Manual Update

Document Title: TMS380 Adapter Chipset User's Guide
TMS380 Adapter Chipset User's Guide Supplement

Document Number: SPWU001D, SPWU003

This document updates the TMS380 Adapter Chipset User's Guide, Revision D, document number SPWU001D, dated July 1986, and the TMS380 Adapter Chipset User's Guide Supplement (which includes Revision E), document number SPWU003, dated August 1987.

FIGURE 4-4. DRAM Schematic

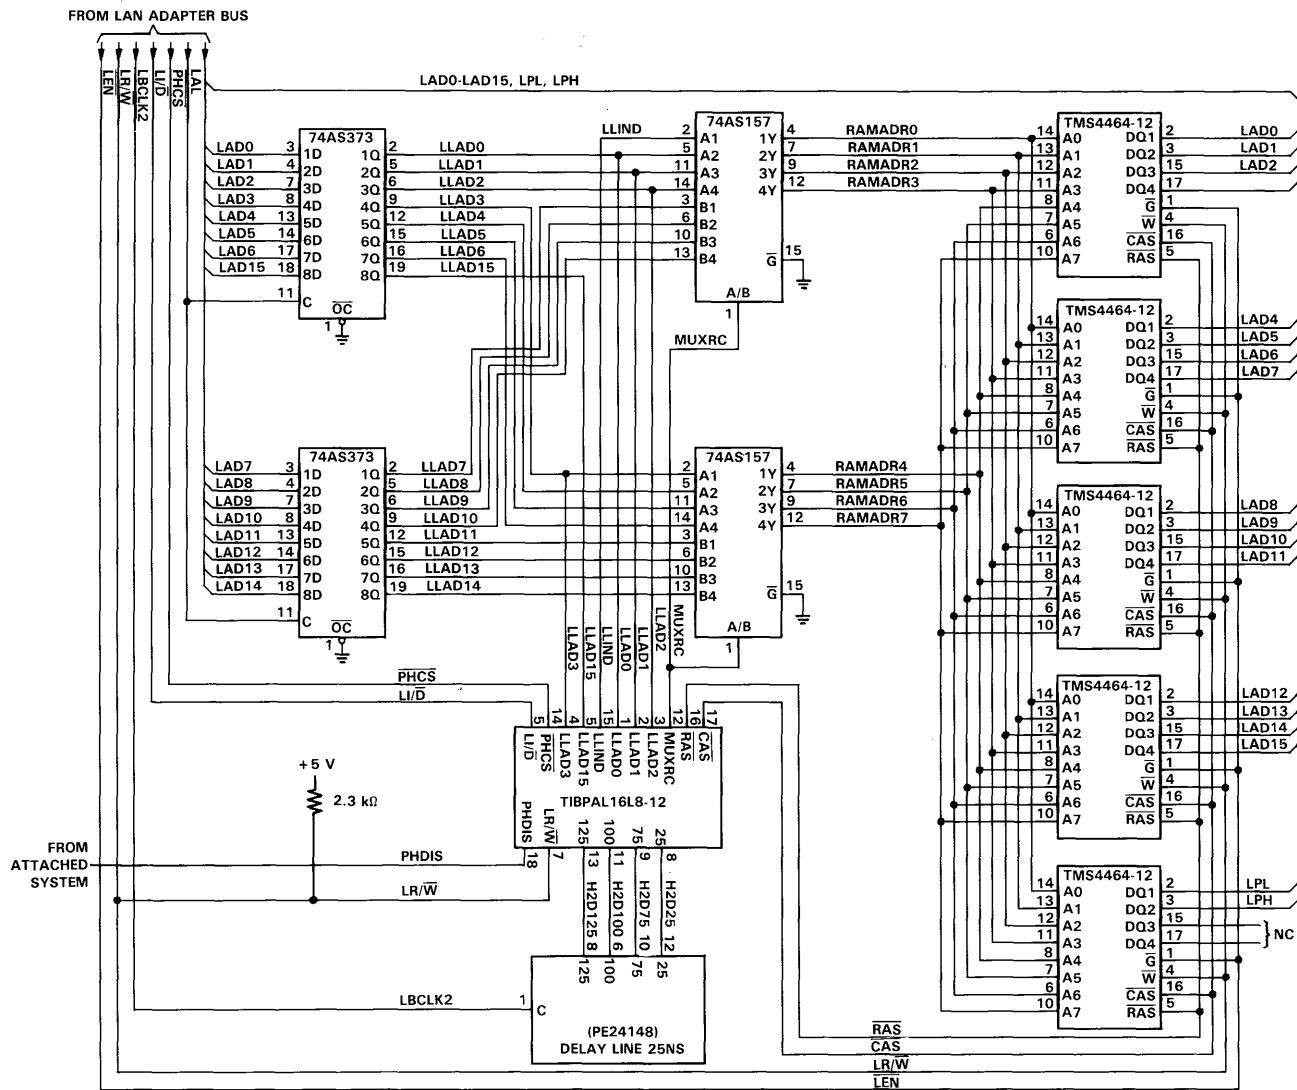
4-4 Figure 4-4 should be replaced with the new Figure 4-4 included on page 19 of this update.

NOTE: PHDIS signal is controlled by host software to disable PHROM and enable DRAM from >C000 to >FFFE.

FIGURE B-2. PC Family Card Logic with Modifications

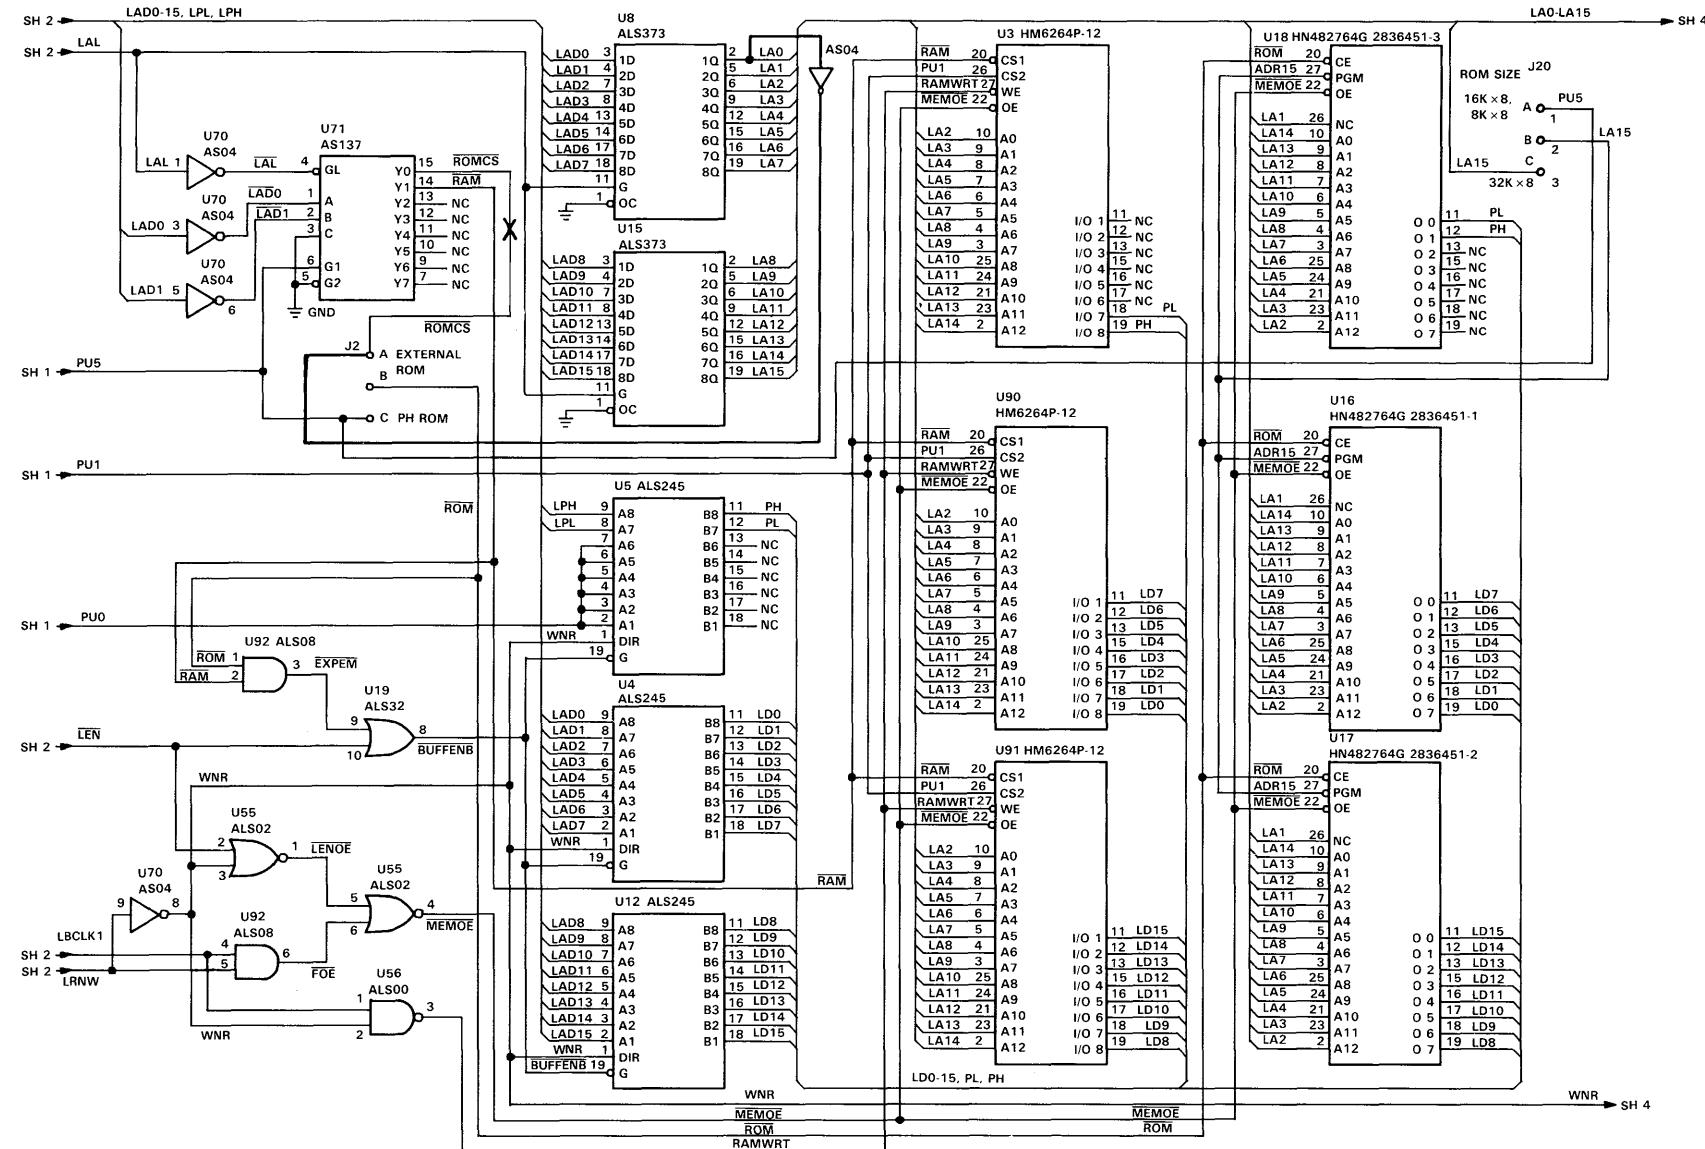
- A-37 The manual updates listed in the appendix are also included in this update.
- B-3 Replace Figure B-2 with the new Figure B-2 on page 20 of this update.
